To: Members of Dublin City Council
From: Dana L. McDaniel, City Manager 
Date: November 17, 2016
Initiated By: Vincent A. Papsidero, FAICP, Planning Director
Devayani Puranik, Planner II
Re: Final Plat – Ballantrae Woods (15-119FDP/FP)

15-119FDP/FP
 Final Development Plan/ Final Plat
 Ballantrae Woods
 Cosgray Road

BALLANTRAE WOODS

FINAL PLAT

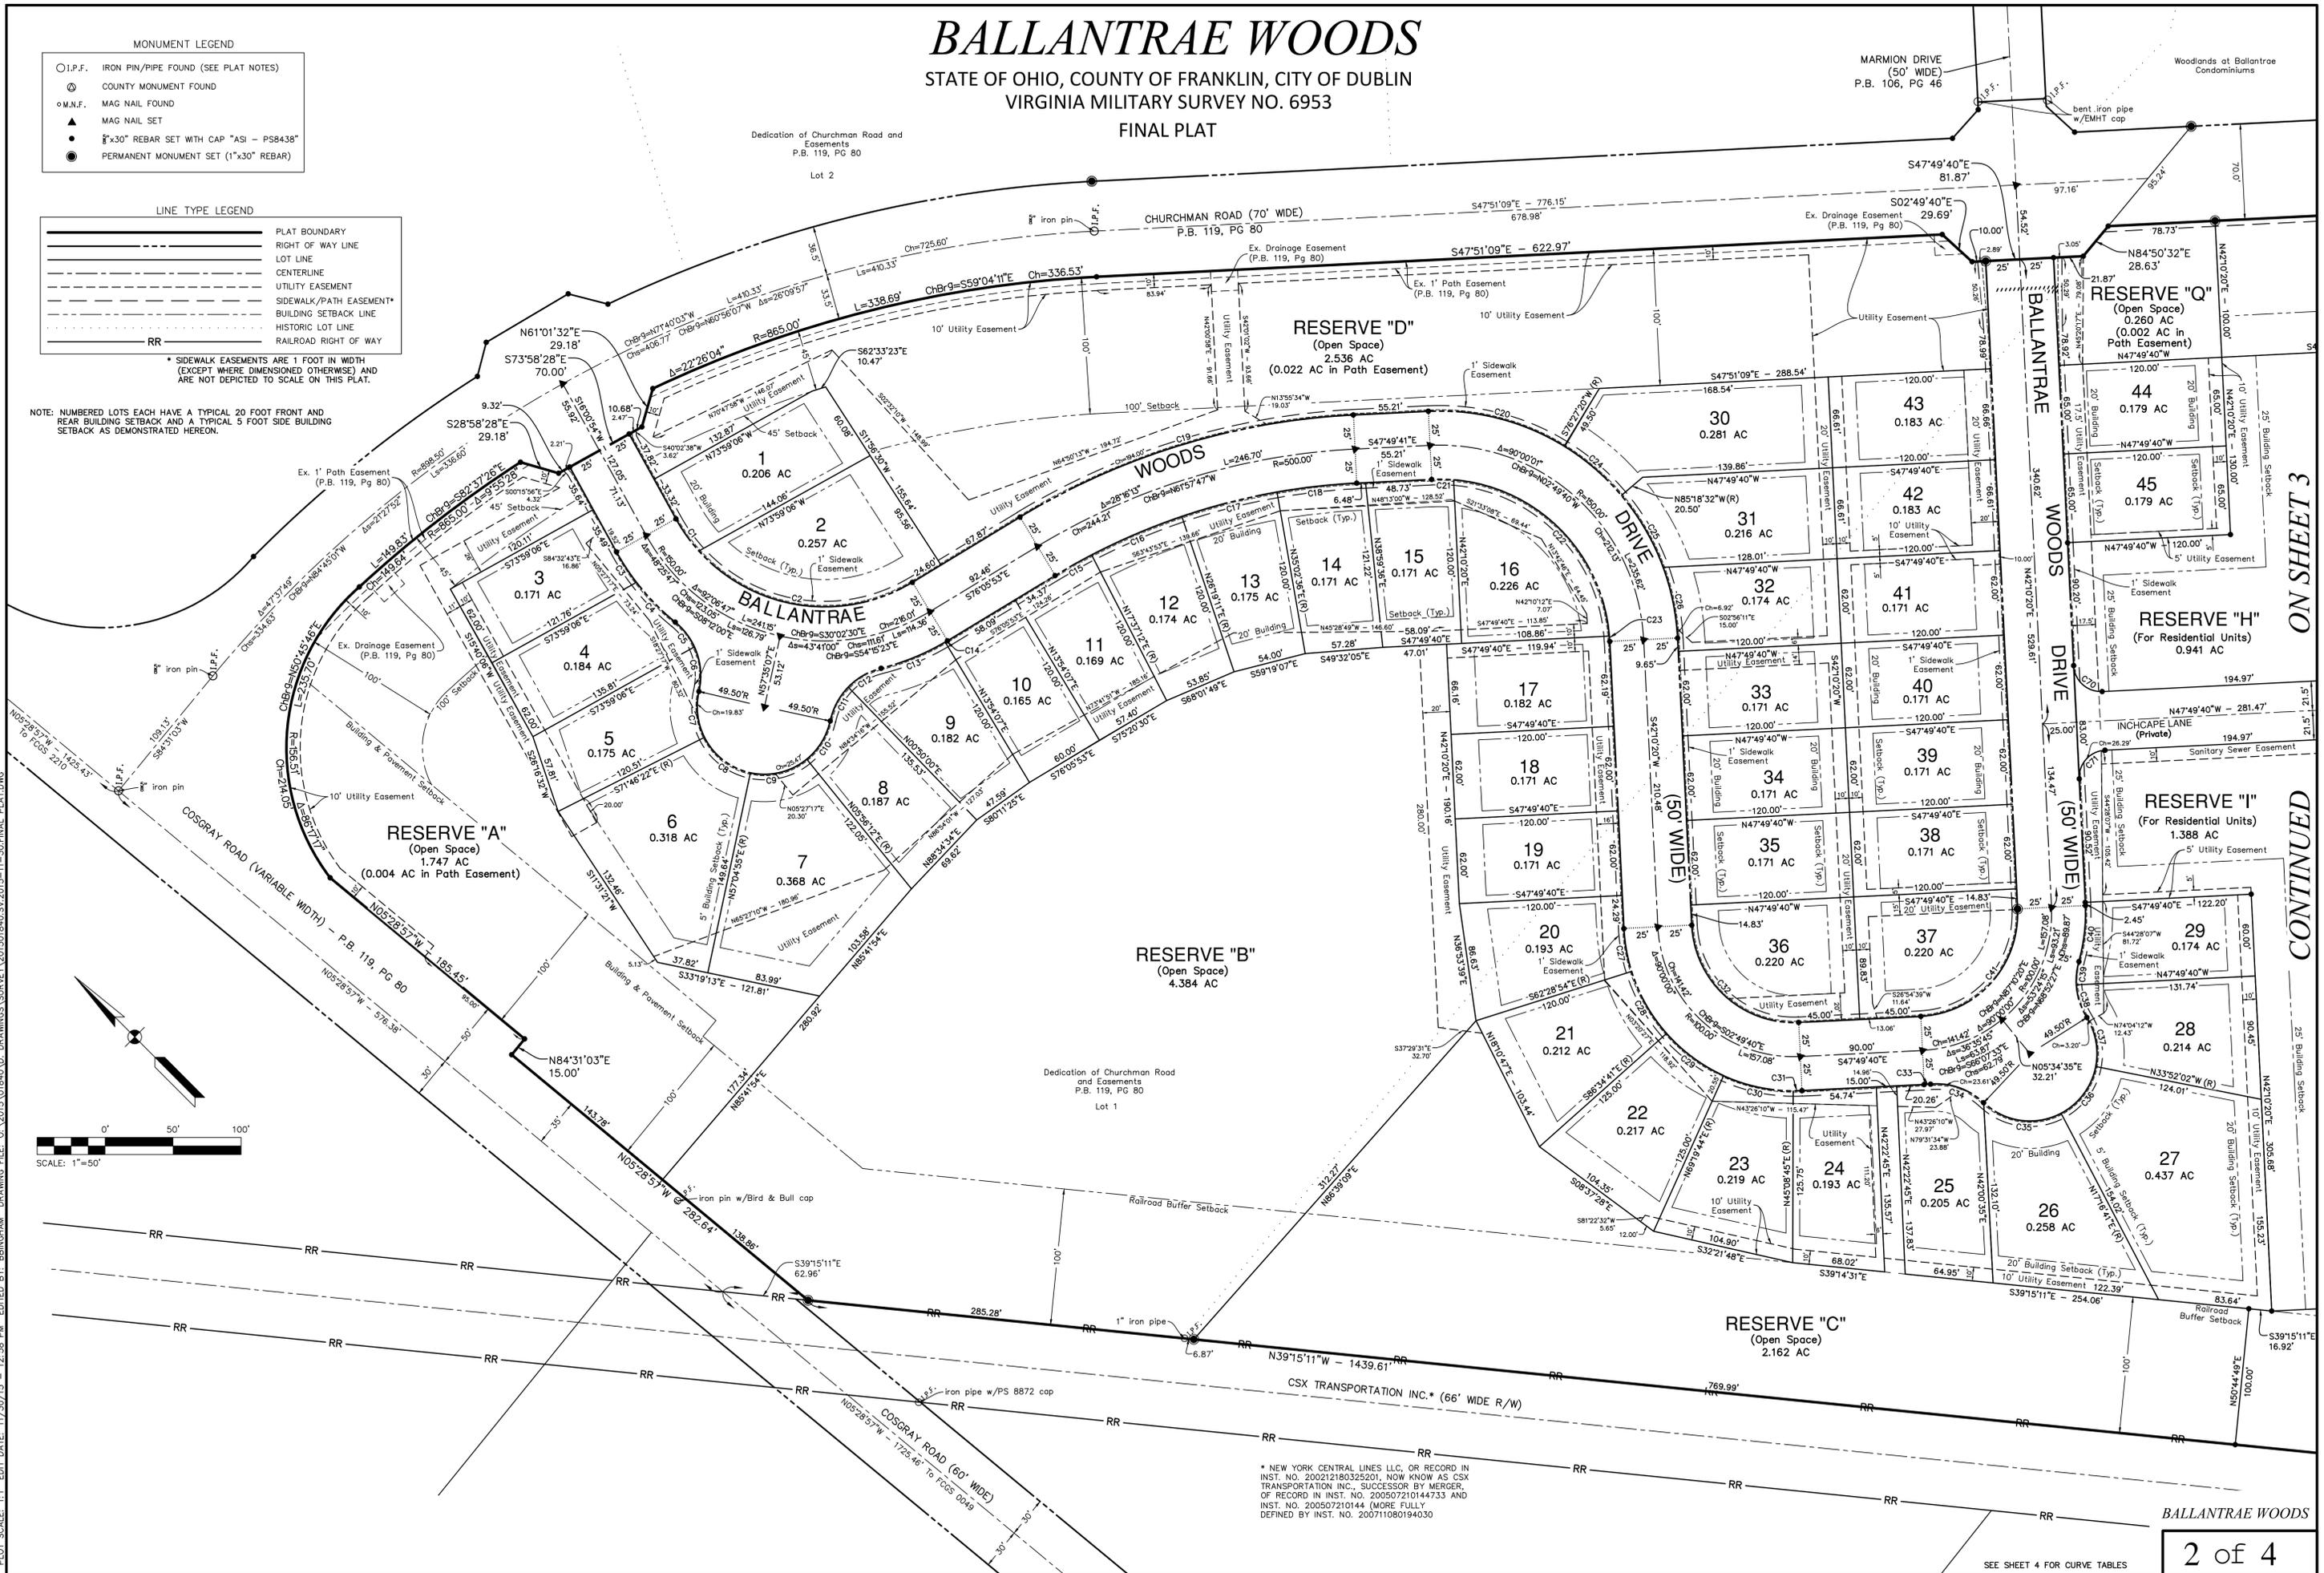
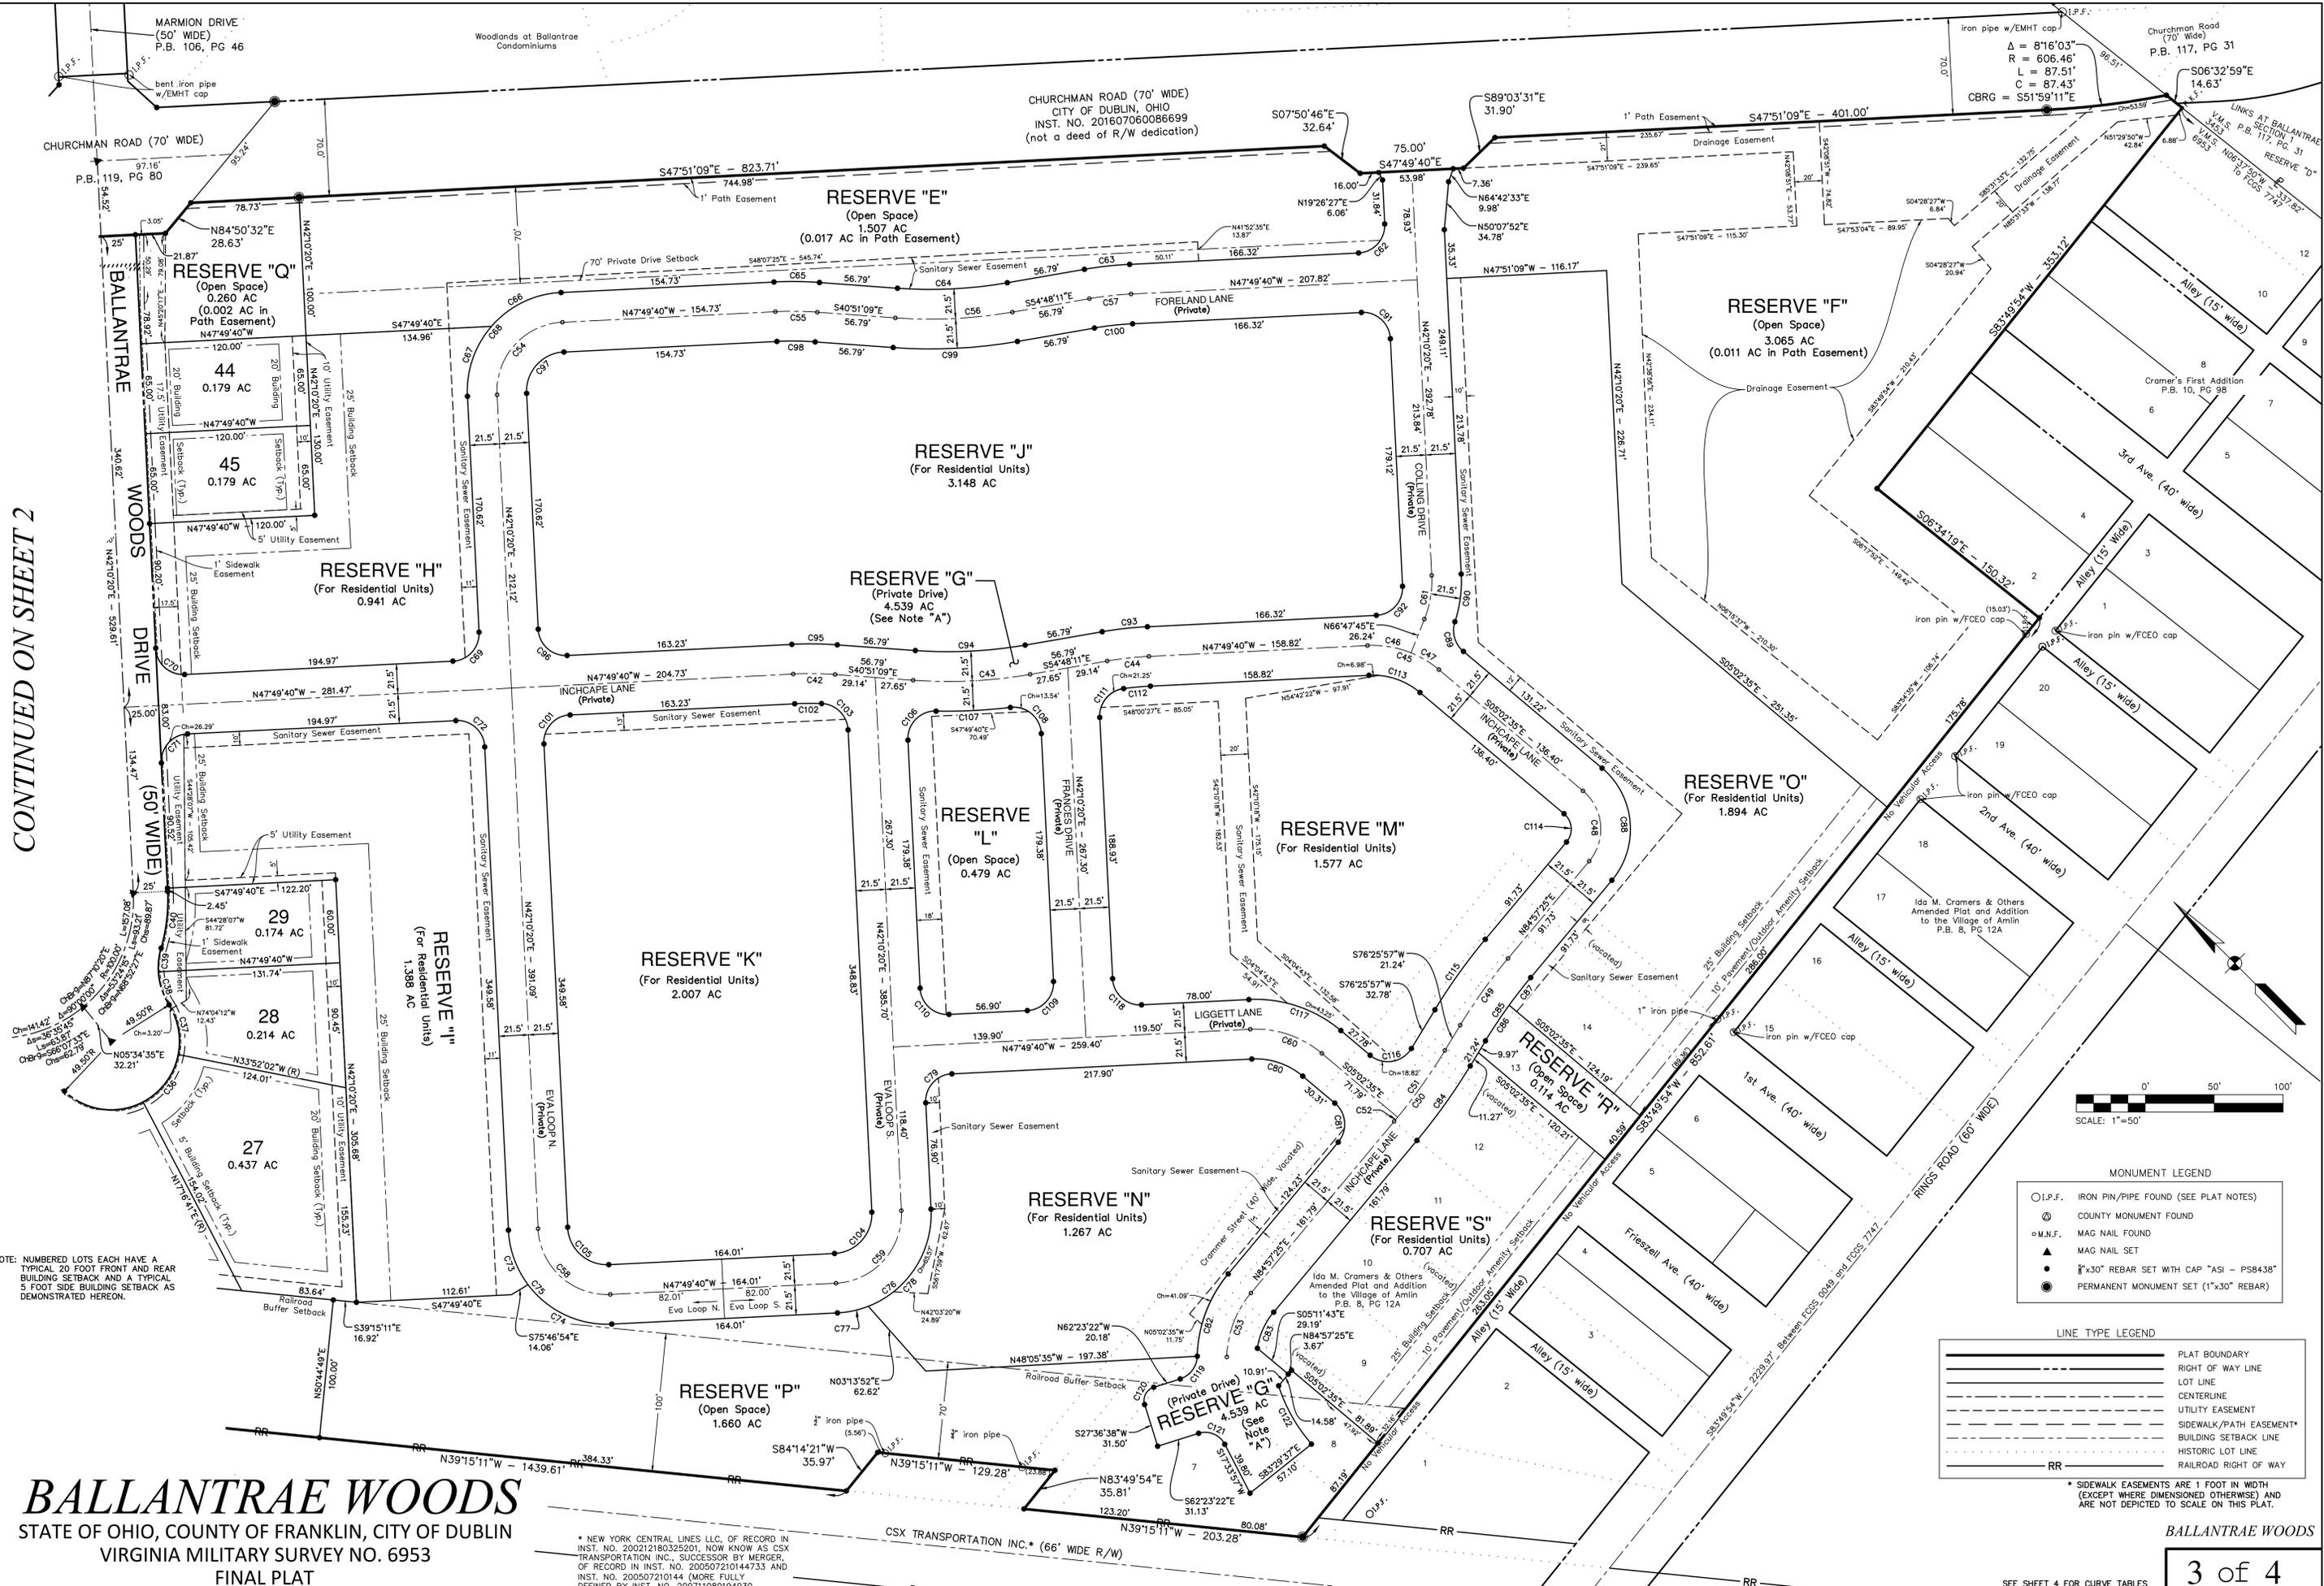
- 1) The applicant ensure that any minor technical adjustments to the plat, are made prior to City Council submittal; and,
- 2) The applicant revises the plat and summary table to include "Reserve R" for landmark tree protection and reserve area numbers and ownership details per approved development text.

Ms. Puranik presented the Final Plat that shows all the required setbacks, right-of-ways, and lots, but said the applicant needs to show continuous building lines and include "Reserve R" that was part of the Preliminary Development Plan that includes the preservation of landmark trees.

Ms. Puranik presented the Site Plan and noted the two landmark trees that are part of the reserve, which was not reflected on the Plat.

The applicant has met the conditions for the final plat.
